APPENDUM #1	06-11-12
Revisions	Date

1 SLAB PLAN

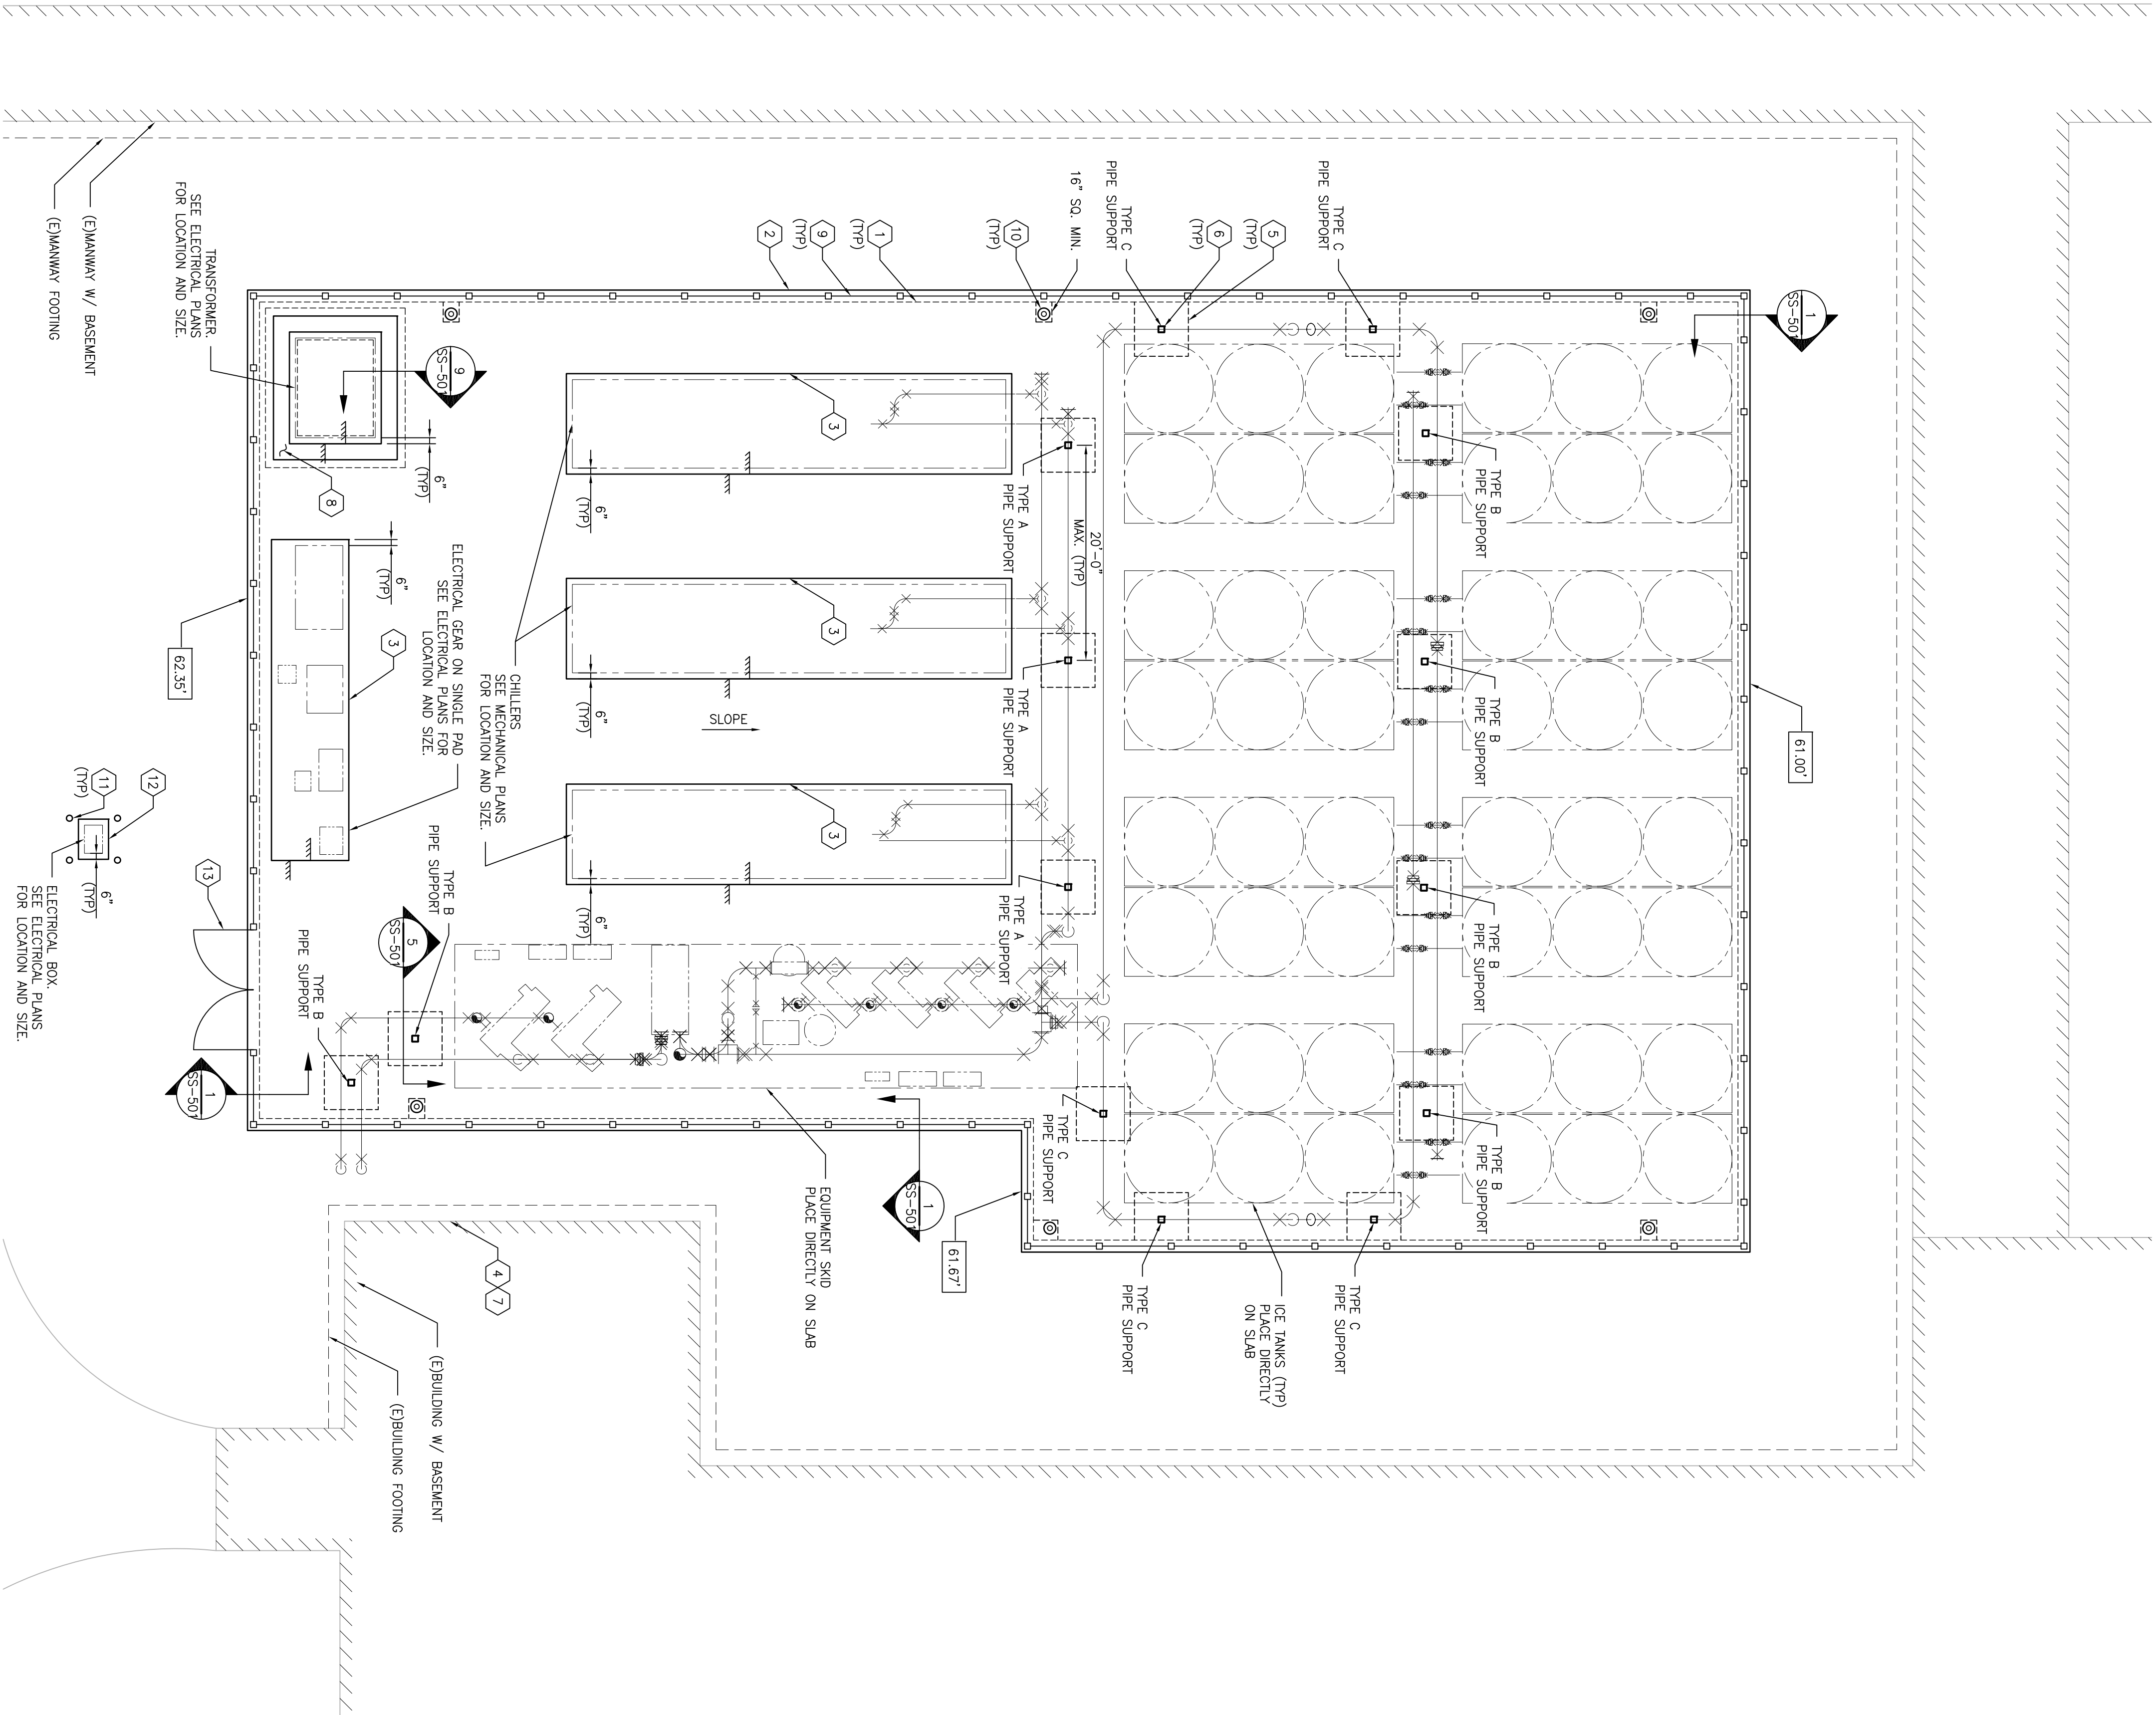
- LIGHT STANDARDS. PROVIDE (4) 3/4" x 8" x 30" L.G. HOOKED ANCHOR BOLTS. ENLARGE EXISTING CONCRETE SLAB TO 10'-0" WIDE. PROVIDE 4" DEEP LAYER CRUSHED STONE DRAINAGE FILL BELOW SLAB. SEE ELECTRICAL PLANS FOR LOCATION. (SEE DETAIL 10/SS-501) A
